Memorandum

To: Historic Landmark Commission

Re: Revisions to application for Everest Builders, New Construction, 470-06-56, located at 256, 262 and 268 South 700 East and 673 and 695 East 300 South Street in the Central City Historic District (470-06-56).

HISTORIC LANDMARK COMMISSION
STAFF REPORT

Attachment A: Revised elevations and site plan

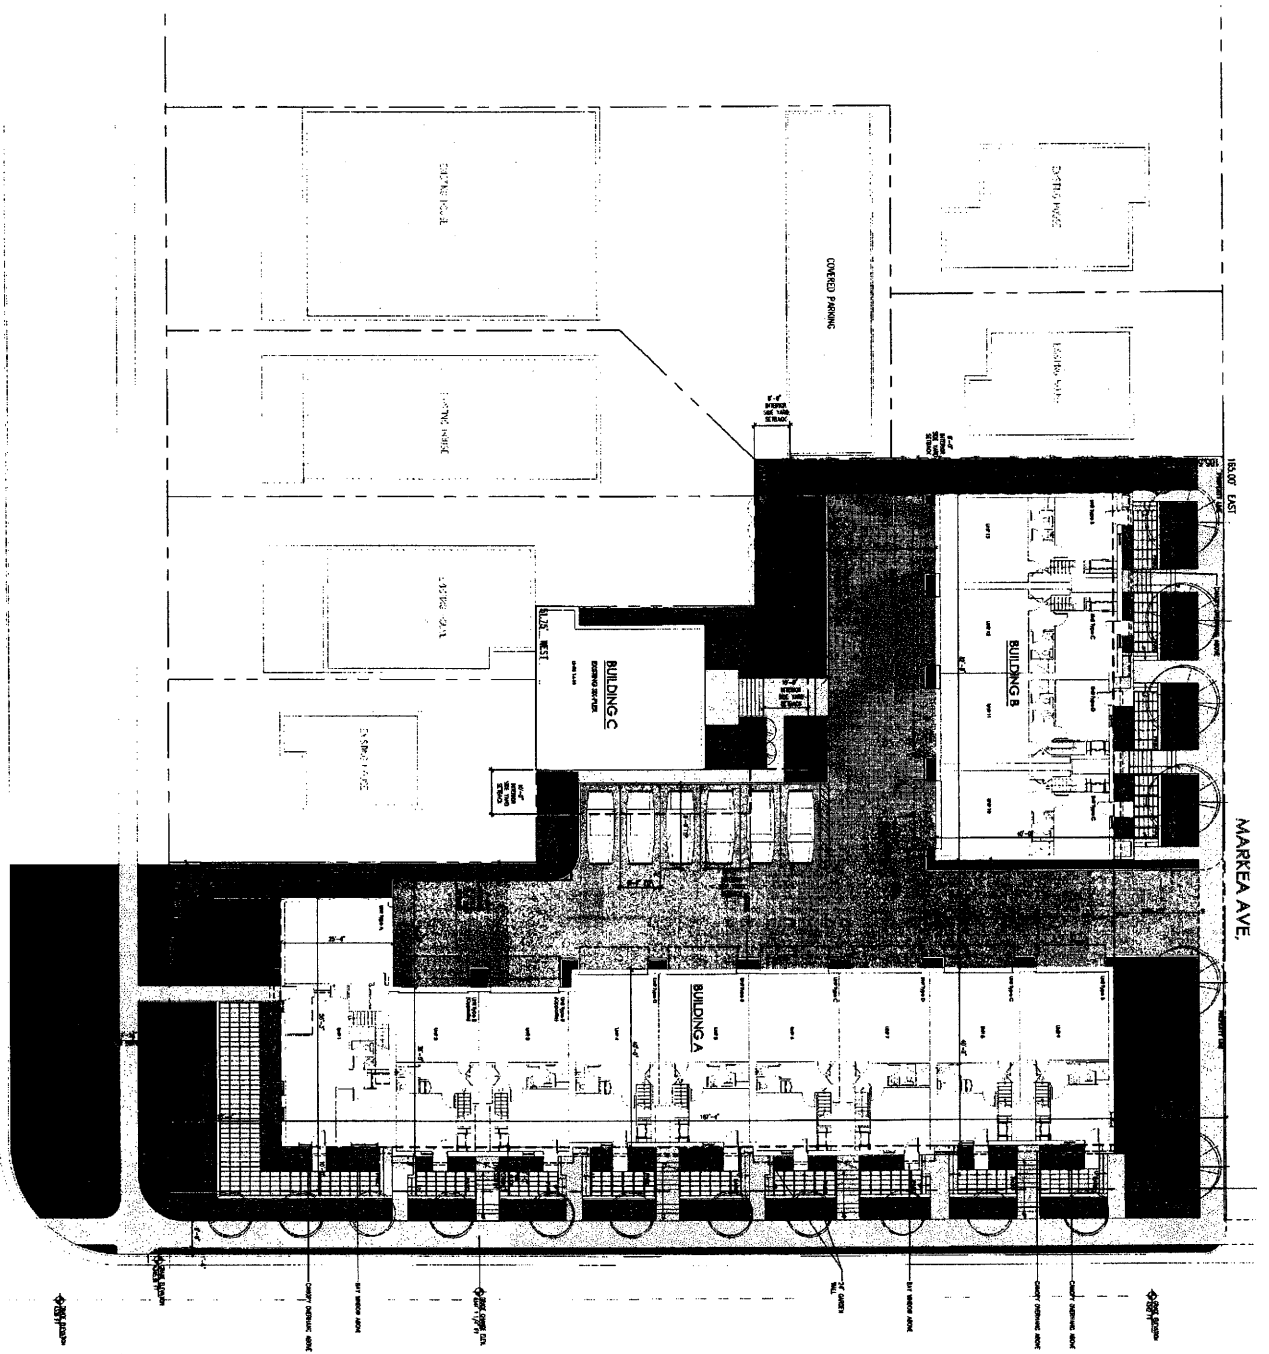
Discussion of Revised Design:

- The new design does not change the width of the building facing 300 South.
- The new design does not have a porch; however the width of the stairs is wider and there is a small landing at the top of the stairs at a new main entrance.

Discussion of Revised Design:

- The windows, which were formerly pushed off to one side, are now centered within each module and a few windows have been added or slightly moved to create more symmetry to the facade.

- More information is needed about the framing of the windows; however it appears that they are still more typical of commercial buildings rather than residential.

- The main entrances, which were originally recessed, are now pulled out to the wall face. The windows surrounding one side and the top of the glass doors, serves as a modern interpretation of traditional sidelights and transoms.

- Two buildings were lessened in square footage so that the garage, originally designed to face 300 South, could be moved to the interior of the project. The design of 300 South façade has had no significant alterations with the exception of the area that was originally garage doors are now brick. The relocation of the garage allowed the driveway to be removed from 300 South.

Discussion of Revised Design:

- The design of these elevations has not changed significantly. The garage on 300 South has been relocated and replaced with a brick wall.
- The overall impact of front patios (submerged courts) has been lessened by green space next to the building and by using a twenty-four inch (24") wall. What was originally designed as poured concrete patios is now patios of concrete pavers.

1898 Sanborn

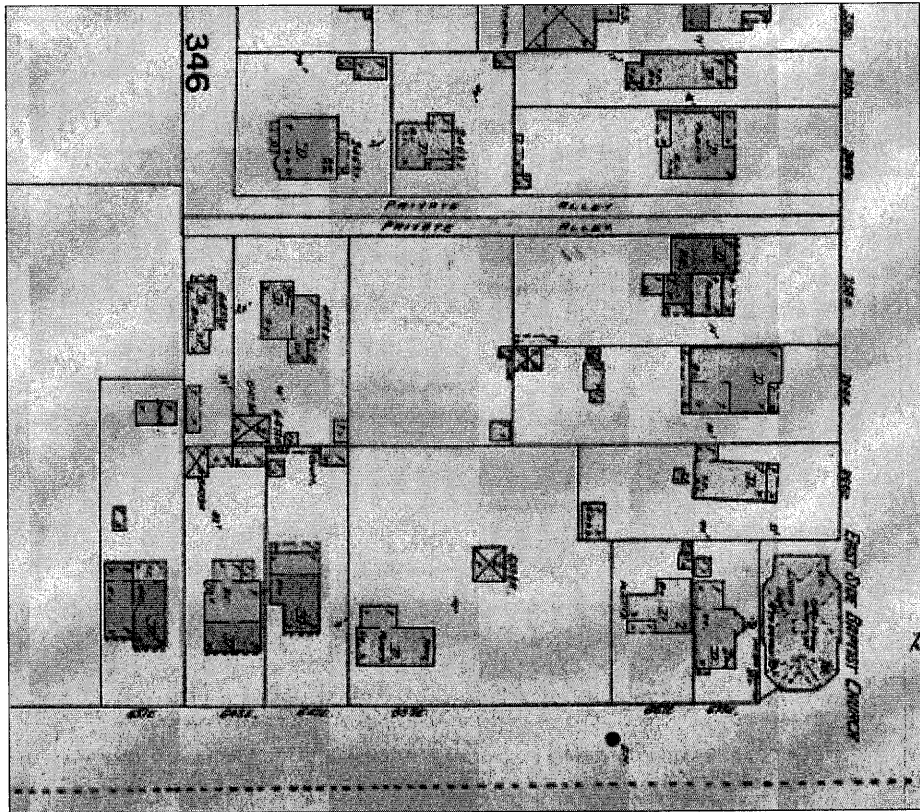
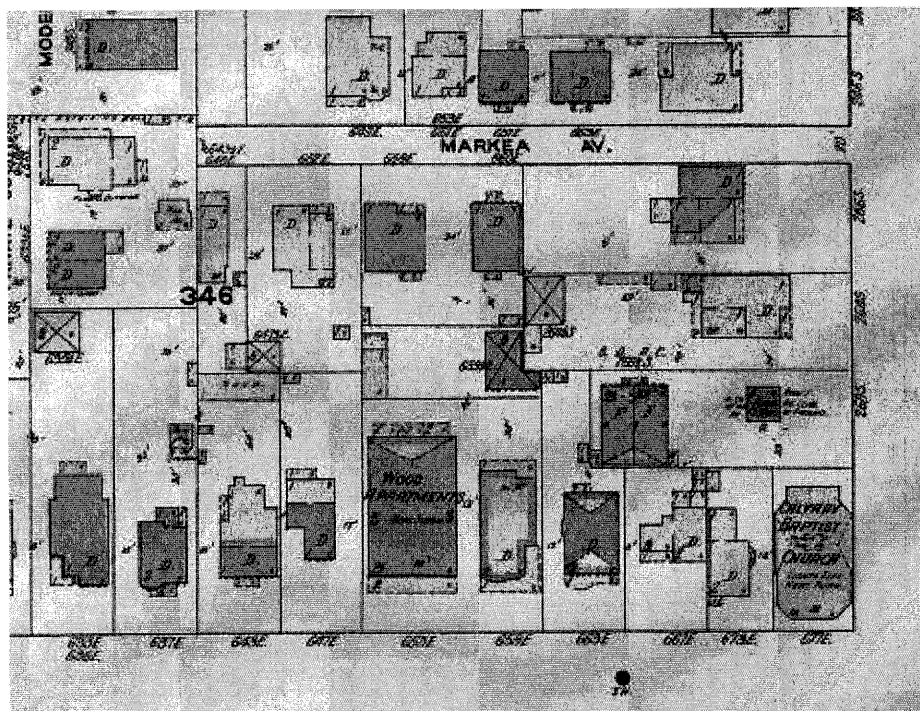
Discussion: The ordinance and design guidelines require preservation of the district's street plan. Originally Markea Avenue was a private alley that developed into a mid-block street sometime between 1898 and 1911. Please see Sanborn maps that follow. Even as an alleyway, there were already houses oriented towards this street. In keeping with the original development of the area and the initial plan submitted the applicant, staff recommends that there be no on-street parking on Markea Avenue. All parking should be interior.

Staff recommends extending the unit at the corner of 300 South and 700 East so that there is enough room for access to a two bay garage from the interior, thereby removing the garage that currently faces 300 South. Staff does not believe that this alteration would significantly change the original site plan already conceptually approved by the HLC.

The submerged court that fronts the new structures and the walkway that parallels 700 East is inappropriate for the district. Staff recommends that the size of the court be decreased, especially at the corners. The walkway for each unit should travel from the main entrance directly to the sidewalk, as seen elsewhere in the district.
